### AMENDMENTS TO THE DRAWINGS

## REMARKS

These remarks and the accompanying amendment are responsive to the Office Action made final and dated September 15, 2005 (hereinafter, the "Office Action"). Claims 2-5, 7-26 and 28-48 were pending at the time of the last examination. By this amendment, Claims 16 and 17, leaving Claims 2-5, 7-26 and 28-48 still pending. Reconsideration and allowance for the above-identified application are now respectfully requested in light of these remarks and the accompanying amendments.

FIG.1

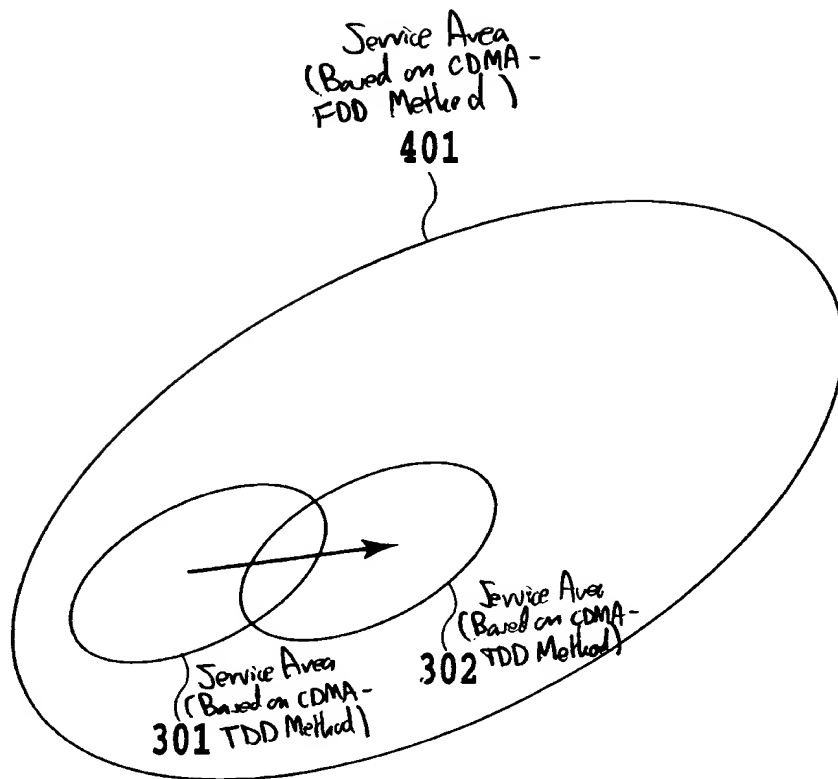
Section 2 of the Office Action objected to the drawings indicating that all blocks in the Figures 1 and 3-7 should be labeled with descriptive legends. The drawings are amended herein to include descriptive legends.

The attached sheets of drawings include changes to sheets 1/9, 3/9, 4/9, 5/9, 6/9 and 7/9. These sheets, which includes Figure 1 and 3-7, replaces the original sheets 1/9, 3/9, 4/9, 5/9, 6/9 and 7/9, respectively, including Figures 1 and 3-7.
